Technical Bulletin

Mettler-Toledo, Inc.
Scales & Systems

Number: MTFW-25-00
Date: 11-09-00
Model: 645
Subject: Center Clamp Pusher

83022400A Package Pusher Plate

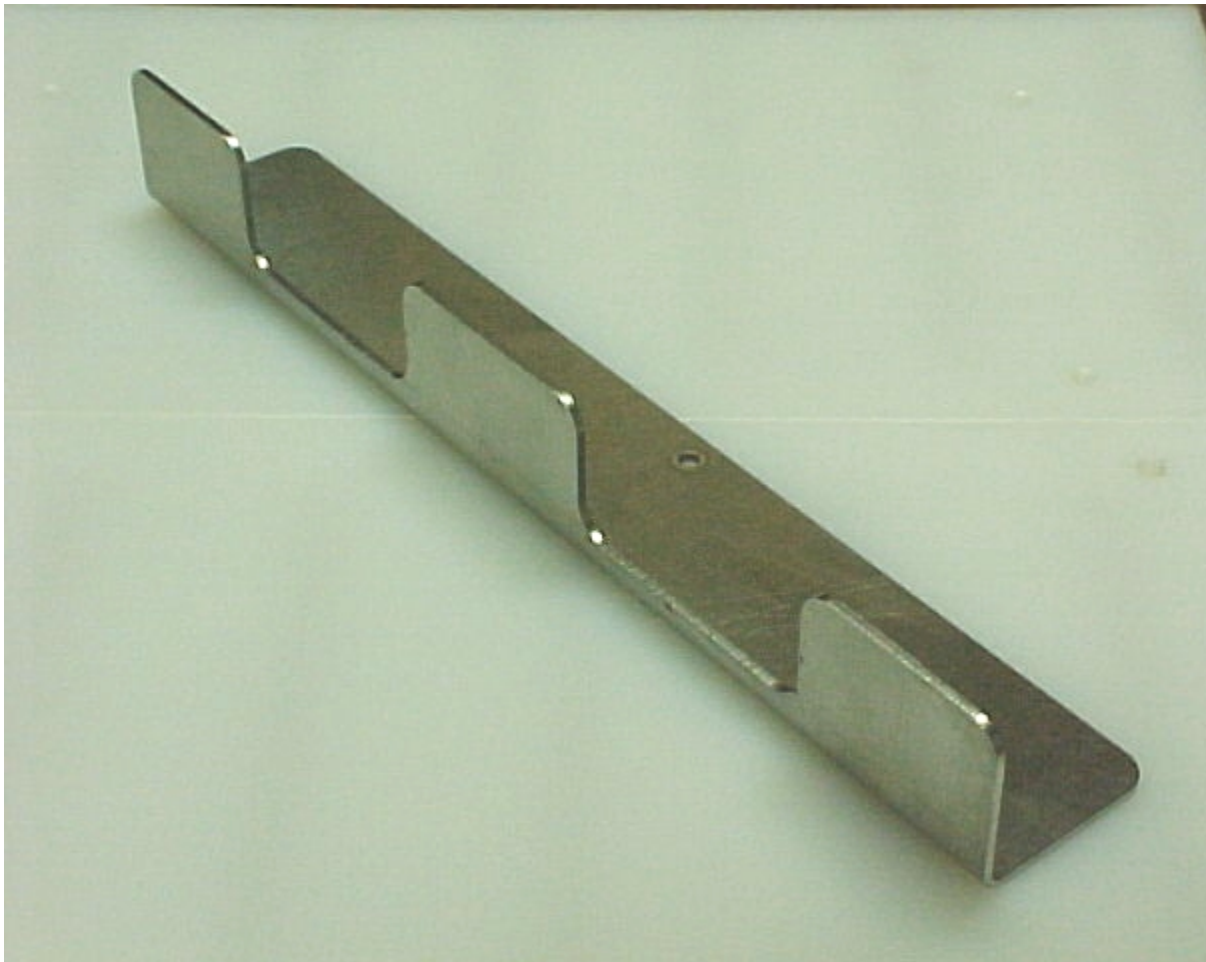
A new wide package pusher P/N 83022400A has been developed for use on all 645 Wrappers. The new pusher disperses the pressure against the tray over a wider area. This will decrease the deflection on the sides of some of the weaker trays improving the wrap quality. All 645 Wrappers beginning with S/N 3092580-3KB include this new package pusher.

The current pusher plates P/N 82928000A and P/N 82734800A and pusher pad P/N 82734900A are discontinued. When servicing any of these part numbers use the new package pusher P/N 83022400A. Make note in your 645 Plus and 645 XL parts manuals of this change.
